Executive Director's Recommendation

Commission Meeting: July 12, 2012

PROJECT Vietnam Veterans Memorial Visitor Center Lincoln Memorial Washington, DC	NCPC FILE NUMBER 6597
	NCPC MAP FILE NUMBER 1.43(73.10)43574
SUBMITTED BY United States Department of the Interior National Park Service	APPLICANT'S REQUEST Preliminary approval of site and building plans
REVIEW AUTHORITY Approval Public Law 108-126 and 40 U.S.C. 8905	PROPOSED ACTION Approve as requested
	ACTION ITEM TYPE Staff Presentation

PROJECT SUMMARY

Figure 4: Concept Design Review – December 2007

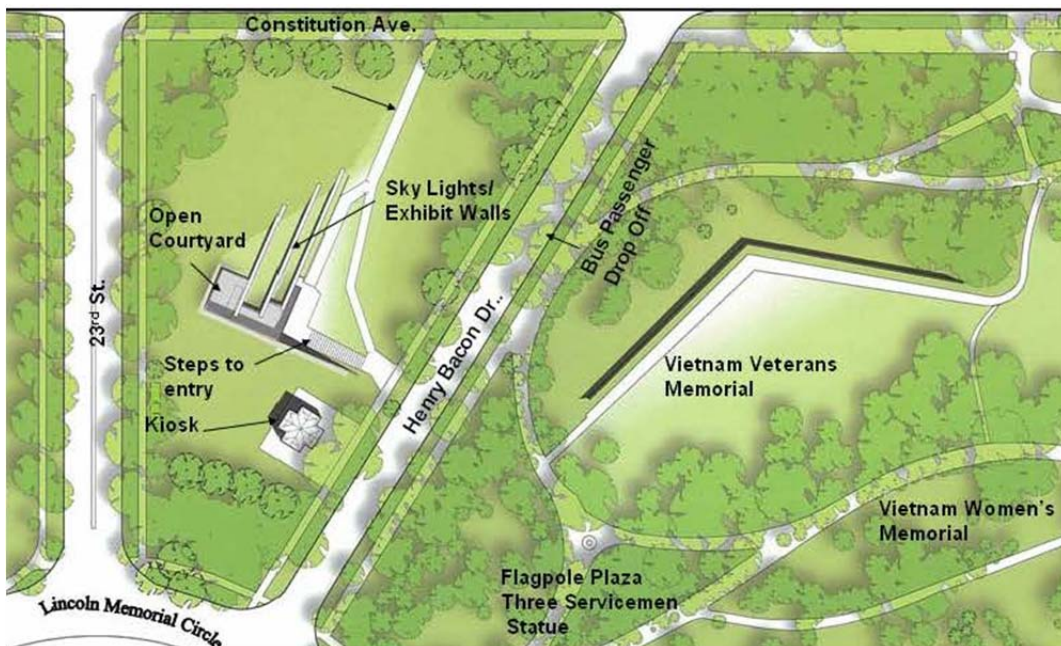
The Commission approved the site for the Vietnam Veterans Memorial Visitor Center on August 3, 2006 conditioned upon the NPS implementation of mitigation measures necessary to reduce the otherwise significant impacts of the site selection outlined in the Executive Director's Finding of No Significant Impact (FONSI). Both the FONSI and the Commission Action included the design guidelines developed by NCPC and CFA staffs. In June 2007, the NPS presented three alternative concept designs to NCPC during an information presentation. In October 2007, CFA approved the concept design with comments and conditions. In December 2007, the Commission commented on the concept design and indicated that while the design met some of the design guidelines, it did not meet others and the scale and visibility of the Visitor Center needed to be reduced. The Commission noted that while the Visitor Center was designed as an underground facility, the proposal included a system of linear ramps that would need to be constructed as well as linear skylights that intruded into the landscape.

Figure 5: Revised Concept Design - June 2009

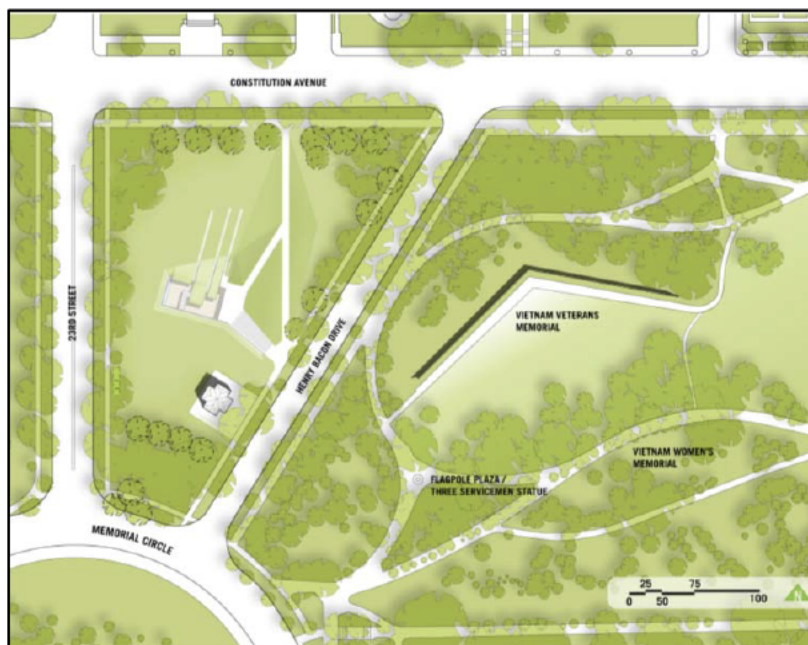
In June 2009, the Commission commented on a revised concept design and found that while improvements had been made since the December 2007 concept design review, additional modifications were required to satisfy the design guidelines. The concept design retained a linear walkway from Constitution Avenue as well as a system of skylights that interrupted the landscape. The Commission requested the following modifications: 1) reduce the scale of the building openings in order to reduce the visibility of the Visitor Center from the Lincoln Memorial and surrounding sidewalks; 2) reduce the visibility of the sunken entrance; 3) increase the area on the site available for multi-purpose recreation; and 4) design the Visitor Center so that a complex system of guardrails is not needed.

The Commission advised the applicant to: 1) eliminate the proposed walk from Constitution Avenue and associated berms so that the Visitor Center was less visible from Constitution Avenue and Henry Bacon Drive; 2) eliminate the skylights to minimize the Center's intrusion on the landscape and to allow for multi-recreational use on the site; 3) reduce the size of the open courtyard and the length of needed guardrails to minimize the visibility from the Lincoln Memorial.

Figure 15: View of the Visitor Center from the Vietnam Veterans Memorial

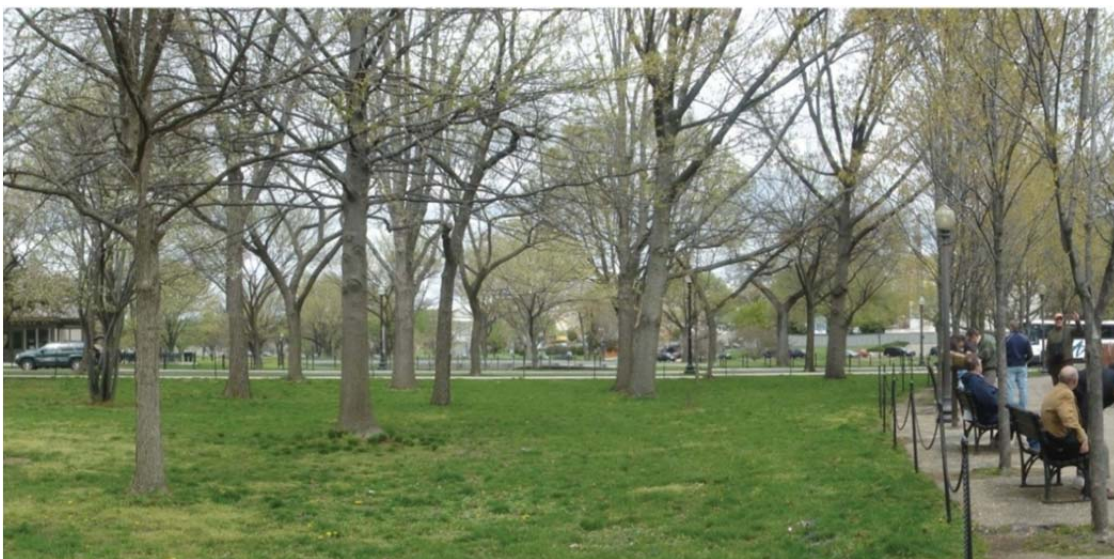
The Visitor Center will be minimally visible from the Vietnam Veterans Memorial. In addition to the distance between the Memorial and the Visitor Center, by placing the facility underground, it will be virtually impossible to see the Visitor Center from the Vietnam Veterans Memorial. Only the top of the horizontal rail along the edge of the green roof will be visible from the Vietnam Veterans Memorial. Views of the Visitor Center will be obscured by foliage, the traffic on Henry Bacon Drive, and the bus drop off.

Figure 16: Proposed grade change

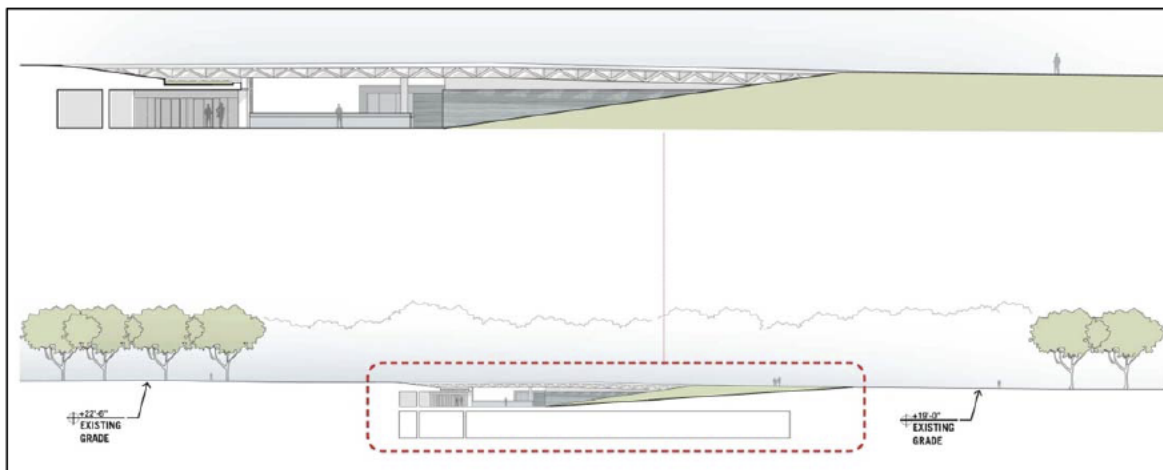
The design of the Visitor Center will raise the grade of the site by 3'6" in order to accommodate the curved approach ramp. The curved ramp will be less intrusive to the landscape than the ramps proposed in previous designs. The entryway to the Visitor Center will be at an elevation of 7' and the slope of the curved ramp is gradual in order to descend from the top of the ramp at an elevation of 20' AMSL. By raising the grade and modifying the design of the ramp from a linear configuration to curved, the impact on the landscape has been minimized.

Figure 21: Proposed location of multi-purpose recreational fields

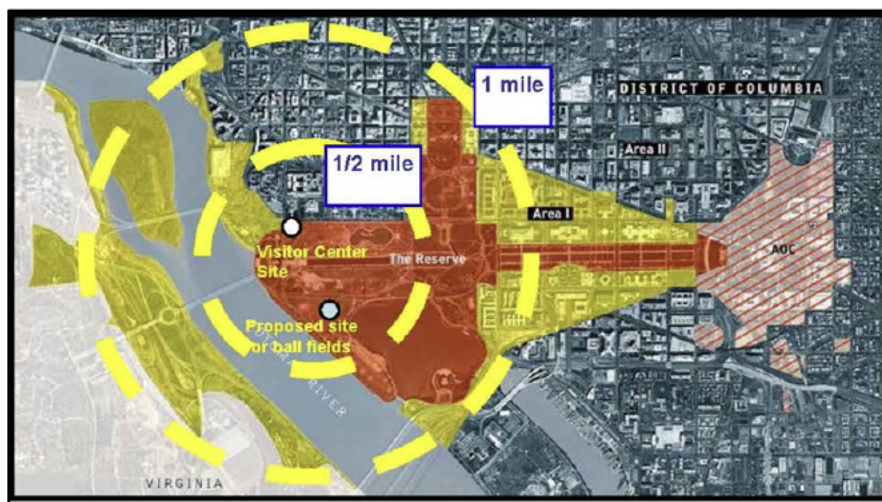
At the time of site selection NCPC required “the NPS to reconstruct softball fields lost as a result of this project on another site within one-half (1/2) mile of Site A.” This mitigation measure was incorporated into NCPC’s FONSI and was intended to address potential significant adverse effects to recreational resources. NPS issued a FONSI in 2007 for the selection of the site for the Visitor Center and this FONSI states that in order to mitigate the loss of ball fields on the site, the NPS will establish multi-purpose fields south of Independence Avenue and west of the proposed (now constructed) Martin Luther King, Jr. Memorial. Currently, there are multi-purpose fields in this location and NPS is committed to maintaining this recreational resource. In addition, the design of the Visitor Center and its orientation on the project site allow for multi-purpose recreational uses as 26% of the project site is available for recreation.
